02P19108 Patent

Amendments to the Drawings

REMARKS

FIG. 1b

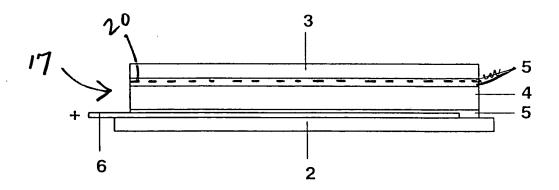
Fig. 1b has been amended to show the phosphor mixture and reference numbers have been added for the phosphor mixture and discharge vessel.

Fig. 1b has been amended to show the phosphor mixture and add reference numbers for the phosphor mixture and discharge vessel. No new matter has been added. Support for the drawing amendment can be found in the Specification as originally filed, in particular, page 8, line 27 through page 9 line 18. The Specification has also been amended to reflect the drawings changes.
